Licence Number L7798/1993/6

Licensee Silver Lake (Deflector) Pty Ltd

Premises Gullewa Gold-Copper Operations
Mining Tenements M59/49, L59/49, L59/64, M59/68,
M59/132, M59/294, M59/356, M59/391, M59/392,
M59/335, M59/442 L59/35, M59/507, M59/336,
M59/522, L59/71, L59/158, L59/159 and L59/160
Morawa - Yalgoo Road

Date of Amendment 10 December 2019

Figure 1: Ore sorters (highlighted in yellow)

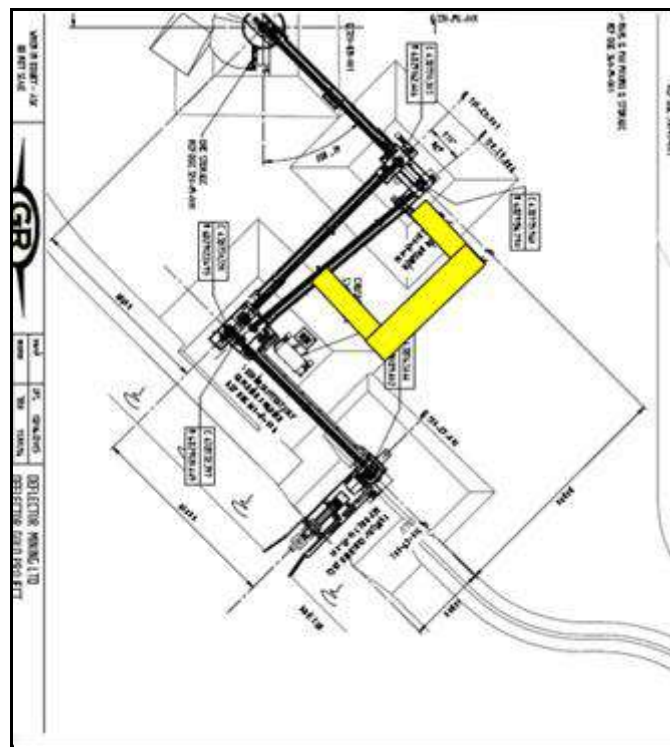
- Install ore sorters adjacent to the existing crushing and screen circuits (see Figure 1 below). The ore sorters are density based sorting equipment used to remove harder basalt gangue rock. The ore sorters consist of small conveyors and feed hoppers feeding the existing conveyor system with selected ore. A total of 760,000 tpa of ore will be feed through the ore sorters first with an expected 10,000 tpa of reject ore sent to the waste rock dump. The ore sorter system will be fitted with dust suppression systems.

- The remaining approximately 750,000 tpa from the ore sorters will then be sent to the existing crushing and screening plant for processing. The existing plant already has a design capacity to process up to 750,000 tpa, and therefore no actual changes are required to this facility. Tailings waste will continue to be sent to the existing TSF for disposal. The total tailings sent to the TSF for disposal will increase to 750,000 tpa, as a result of the increase in throughput at the processing plant by an additional 50,000 tpa.

Figure 4: Rock lined drain entering Salt River

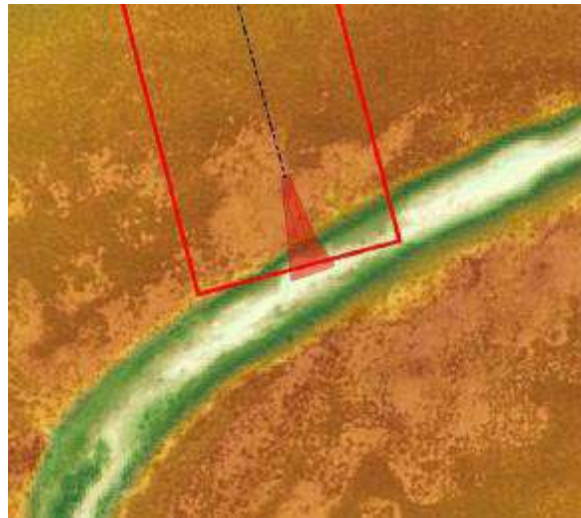
At the dewatering discharge terminus, a designed and purpose-built energy dissipater will be installed. The energy dissipater will consist of a 20m long, 0.5m deep, geotextile lined drain perpendicular to the riverbank with rock armouring extending to the riverbed (Figure 4). The geotextile lining is included to ensure seepage is minimised.

The Licensee proposes to install a 20 m long rock lined drainage area that extends over the riverbank to the bed of the Salt River (see Figure 4 above). Dewatering effluent will be discharged onto the rock drainage area via an energy diffusion device (see Figure 5 above) before flowing into the river through gravity. Dewatering flow velocity is reduced through the use of the energy diffusion device and rock lining. Once the dewatering effluent reaches the river bed the flow rates are expected to be low at less than 0.1 m/s. The installed discharge infrastructure has been designed to withstand a 1 in 20 year flood event.

Figure 5: Energy dissipating pipe terminus

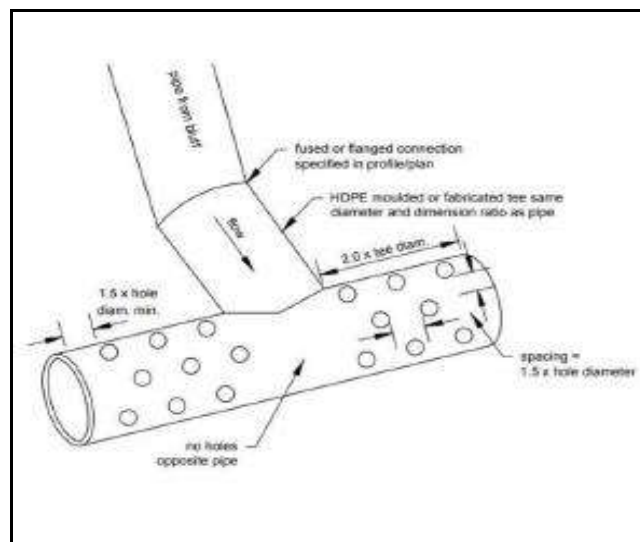
At the end of the discharge pipe, and at the start of the drain, a polypipe 'T' piece/spigot will be installed with holes to ensure water energy is dissipated before free flowing down the drain to the riverbank (Figure 5). This is designed to ensure scour and erosion is minimised both on the riverbank and the riverbed. The pipe will be anchored at the terminus to reduce the risk of movement in a flood event.

Figure 7: TSF and Monarch in-pit TSF Groundwater monitoring bores

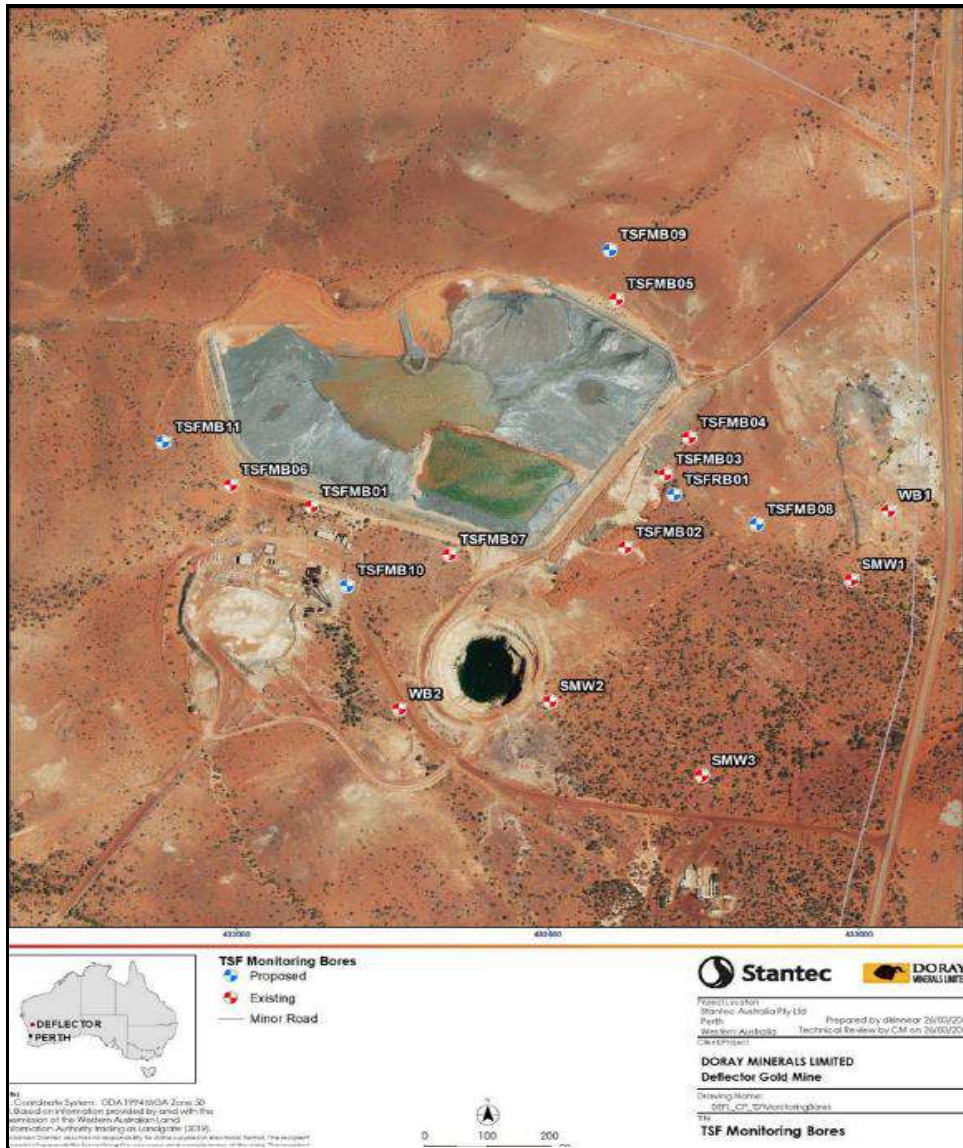
Groundwater Resource Management Pty Ltd (GRM), of behalf of the Licensee, carried out a hydrogeological study and groundwater modelling of the Gullewa Region in early 2019 (GRM, 2019). The groundwater study indicated that levels around the TSF would increase through the Life of Mine because of continuous seepage from the TSF. Routine sampling of groundwater monitoring bores TSFMB01 to TSFMB07, which are located at the toe of the TSF (see Figure 7), indicate there has been a continuous increase in the groundwater levels. However, the groundwater study indicates that the Monarch mine void, which is situated directly south of the TSF, would intercept seepage and control groundwater levels around the TSF. Additionally, the groundwater study indicated the data from groundwater monitoring bores TSFMB01 to TSFMB07 might not be representative of the groundwater conditions in the aquifer, as water levels might be influenced by pressures exerted on the aquifer from the TSF. As a result, the Licensee has now installed four new groundwater monitoring bores (TSFMB08 to TSFMB11) and a recovery bore (TSFRB01) at the TSF (see Figure 7).

These new groundwater monitoring bores are located between 50 to 150 metres away from the TSF as the groundwater study indicates they will better represent the condition of the groundwater around the TSF (GRM, 2019). The Licensee proposes to amend the Licence by replacing the requirement to routinely sample groundwater monitoring bores TSFMB01 to TSFMB07, with sampling of new groundwater monitoring bores TSFMB08 to TSFMB11 instead. The Licensee proposes the replaced monitoring bores located in the toe of the TSF, can be equipped with bore pumps so they can be used to manage rising groundwater levels in that area.

Licensee has installed four new monitoring bores (and one seepage recovery bore) around the existing TSF and proposes these will replace the existing monitoring bores TSFMB01 to TSFMB07 (see Figure 7 above for the location of existing and new monitoring bores). The Licensee also proposes an additional recovery bore will be installed at the northern side of the TSF if water levels are observed to be rising in the new monitoring bores.

Figure 11: Hydrological modelling indicative discharge extents at 15, 25 and 50 L/s rates for Option 1

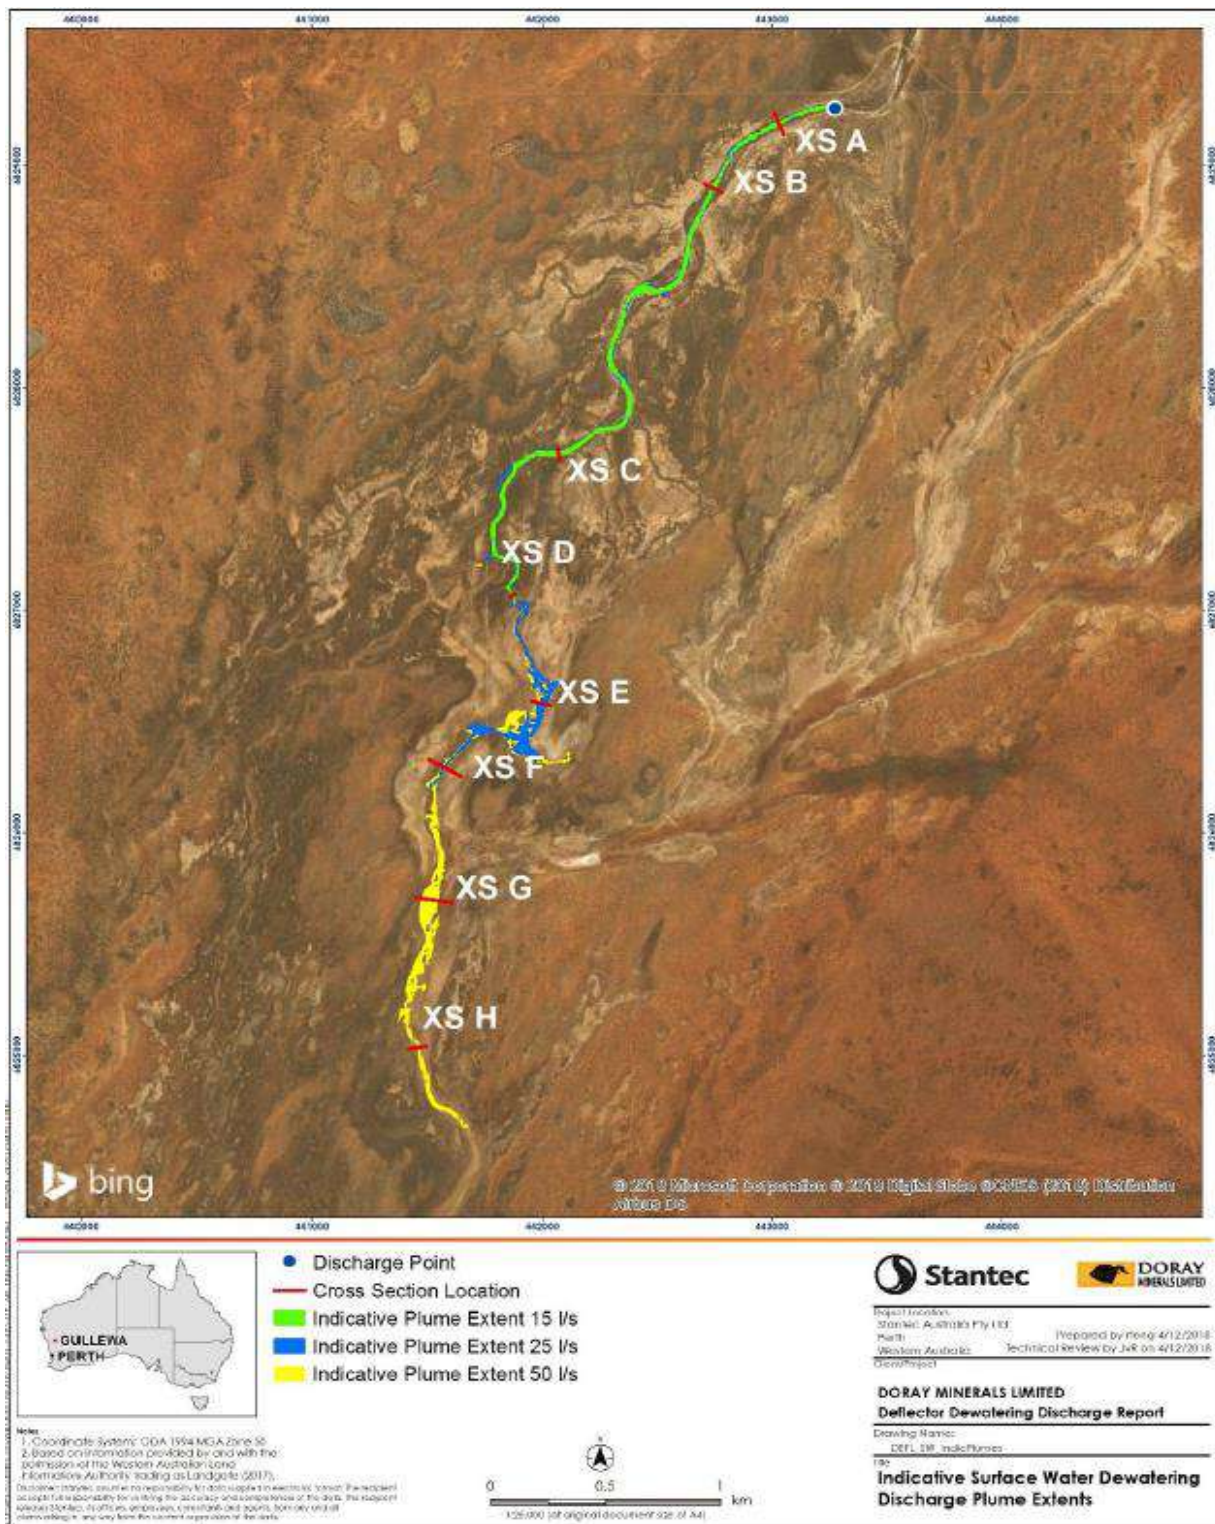
Dewatering plumes were assessed at a discharge rate of 15, 25 and 50 L/s to predict the extent of the downstream impact. At 25 L/s (maximum expected discharge rate at the Premises) the wetted footprint is expected to reach 4.5km. Even at 50 L/s the wetted footprint is expected to dissipate well before the Burra Lake at 6.2 km (see Figure 11 below). The Burra Lake is 24 km away. Groundwater is predicted to extend a further 40 to 60% past the surface extent and therefore still well before the salt lakes systems further downstream.

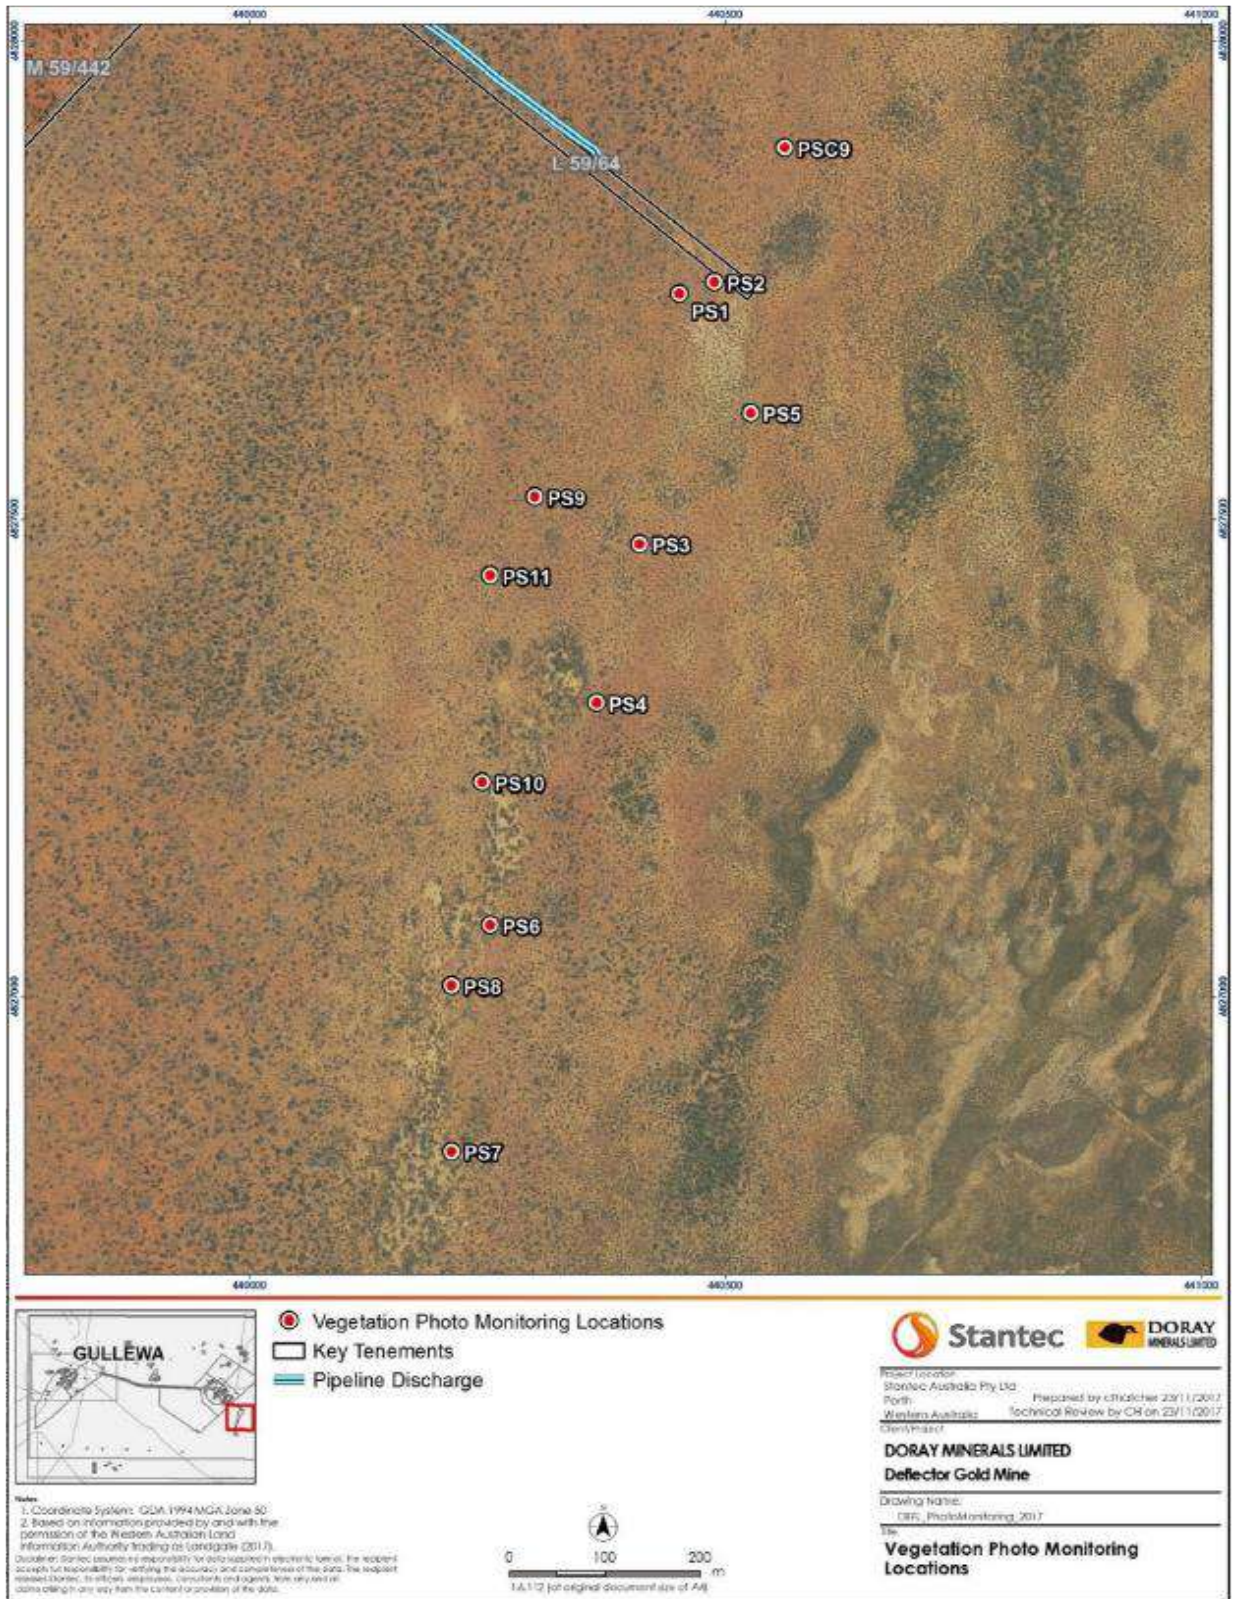
14. The Licence is amended by replacing the Schedule 1 map defined in Table 3.4.2 with the new map shown below.

The location of the vegetation quality monitoring points defined in Table 3.4.2 are shown below.
